**RE: Response to Peer Review Comments  
Proposed Retail Development  
190/194/198 Hartford Avenue (Route 126)  
Bellingham, MA 01923**

Bowman Consulting Group Ltd. (Bowman) has completed a review of the Peer Review comments regarding the proposed retail development to be located at 190/194/198 Hartford Avenue (Route 126) in Bellingham, Massachusetts.

Bowman is in receipt of the Peer Review letter completed by MDM Transportation Consultants, Inc. (MDM), dated November 6, 2025. On behalf of the Town of Bellingham, MDM completed a review of the Traffic Impact Study (hereinafter referred to as "the TIS") completed by Bowman, dated June, 2025; the TIS addendum completed by Bowman, dated September 29, 2025; and the updated Site Plan prepared by Bohler Engineering, dated September 25, 2025. Bowman has prepared responses to the traffic related comments raised by MDM that require attention, and compiled responses to the remaining comments provided by others on the project team.

### SIGHT TRIANGLES FIGURE

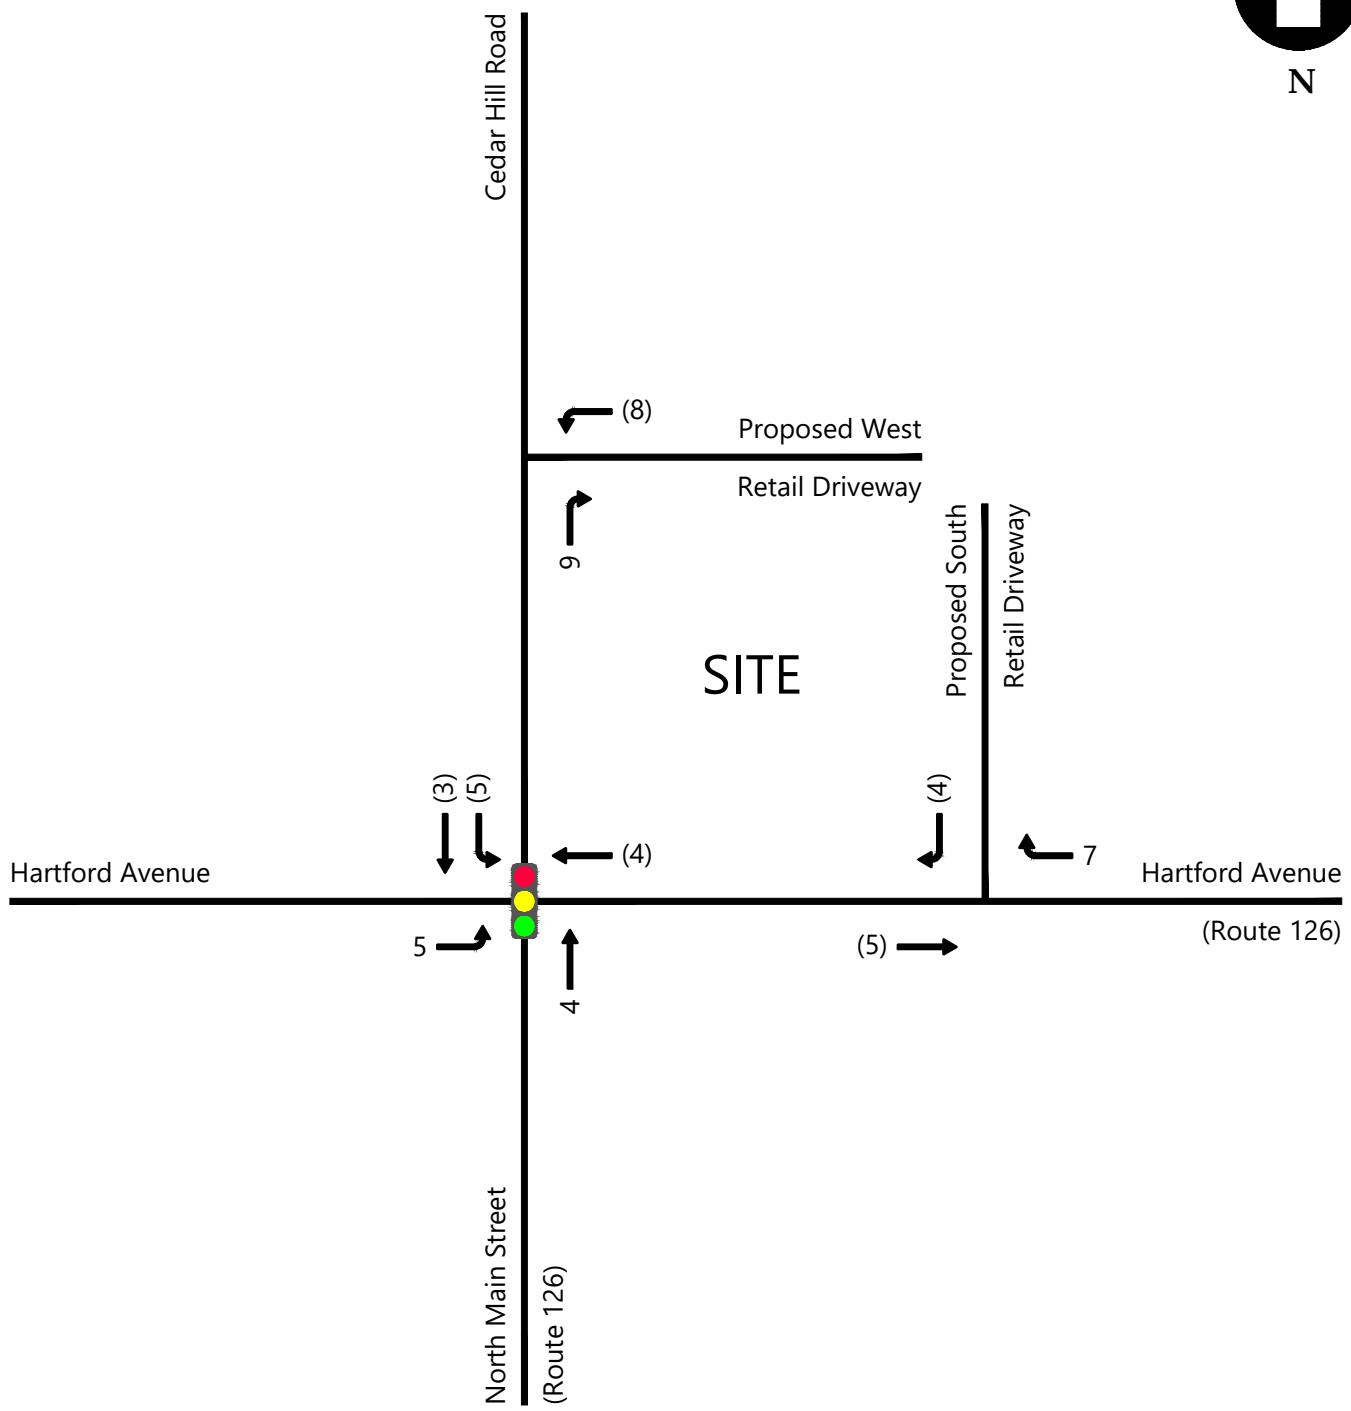
*MDM Comment #4: Sight lines at the proposed driveway locations exceed applicable criteria for the posted speed limit based on review by MDM. Field observations and review of the Road Safety Audit conducted for Hartford Avenue in 2014, travel speeds along Hartford Avenue significantly exceed the posted speed limit; Applicant should therefore confirm that sight line criteria based on the 85<sup>th</sup> percentile travel speeds are met along Hartford Avenue. Applicant should also confirm that site plan features including snow storage areas, signs and landscaping will not impeded sight lines under the future widening of Hartford Avenue.*

*The Site Design Plan should clearly indicate intersection sight triangles and include a note citing that "Signs, landscaping and other features located within sight triangle areas shall be designed, installed and maintained so as not to exceed 2.0-feet in height. Snow windrows located within sight triangle areas that exceed 3.5-feet in height or that would otherwise inhibit sight lines shall be promptly removed."*

**Bowman Response to Comment #4: The available sight lines at the proposed site driveway locations exceed the minimum sight distance requirements established by AASHTO for the posted speed limit. Adequate visibility is provided in the direction of approaching vehicles at the proposed driveway locations, ensuring safe vehicle ingress and egress. The available sight line at each of the proposed driveway locations are depicted in the attached Figure 1.**

Figure 2  
New Project Trips  
Weekday Morning Peak Hour  
Proposed Retail Development  
Bellingham, MA

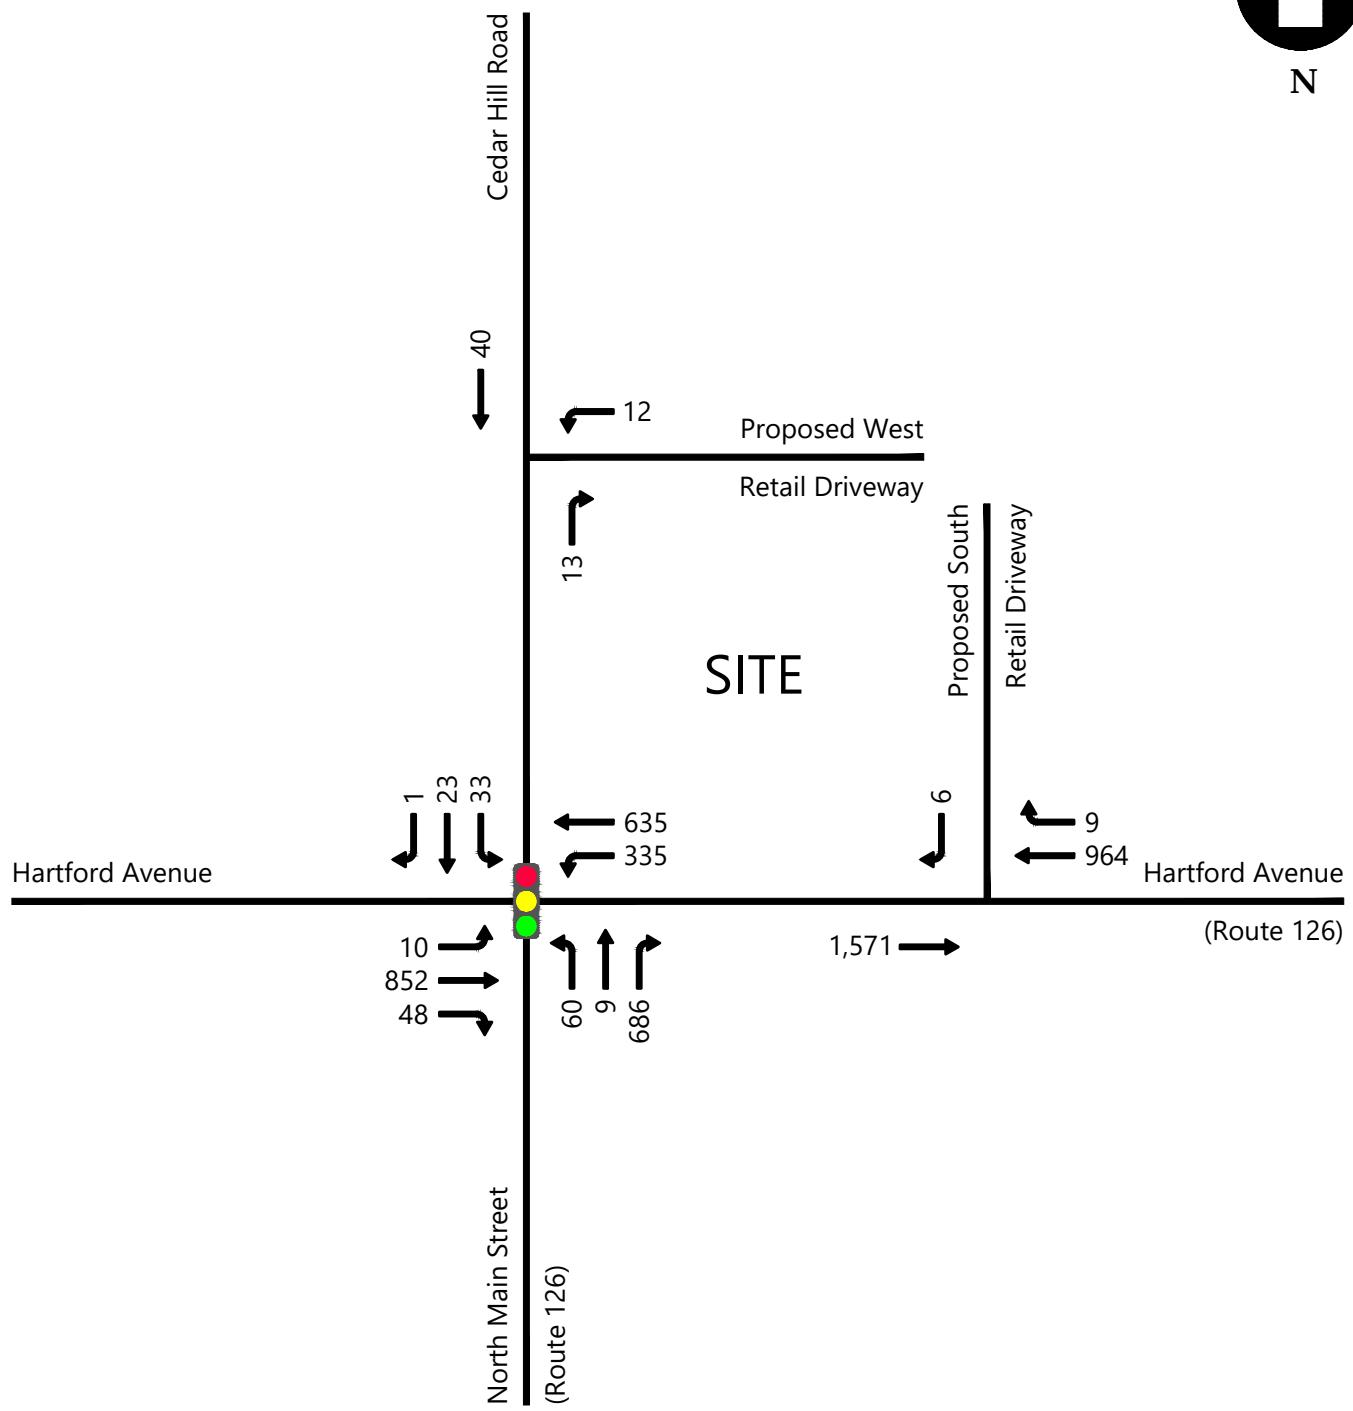
*MDM Comment #6: MDM concurs that the application of ITE trip rates and the methodology used in the TIS to estimate trip generation present a reasonable basis of estimating peak hour trip characteristics of the proposed use for a small retail plaza – a use that typically includes sale of dry-goods and that may also contain small office uses. However, trip generation should be updated to reflect the most current ITE Trip Generation, 12th Edition trip rates which are higher for the AM peak hours.*

*Since specific retail tenant(s) have not been identified, we note that any change in land use category such as drive-in bank, restaurant, coffee/donut shop and others as defined by the Institute of Transportation Engineers Trip Generation are expressly different and often higher traffic generators than general retail uses that would require Applicant to re-evaluate impacts for review and approval by the Town.*

**Bowman Response to Comment #6: The TIS was prepared with the most current ITE Trip Generation Manual (11<sup>th</sup> Edition) at the time of submission as is industry standard. Through conversation with the Town and MDM, Bowman has been asked to provide a comparison of the ITE 11<sup>th</sup> Edition trip generation rates with the new ITE 12<sup>th</sup> Edition trip generation rates that were released after submission of the project materials. Table 1 below shows a comparison of the trip generation estimates based on the ITE Trip Generation Manual, Editions 11 and 12.**

The updated Project-related traffic for the weekday morning peak hour was assigned to the surrounding roadway network based on the trip distribution identified in the TIS. The updated weekday morning peak hour Project trips are shown in the attached Figure 2 and the updated weekday morning peak hour 2032 Build volumes are illustrated in the attached Figure 3,. Bowman has updated the 2032 Build traffic analysis for the weekday morning peak hour based on the updated trip generation estimates and the analysis is summarized in the response to comment #8.
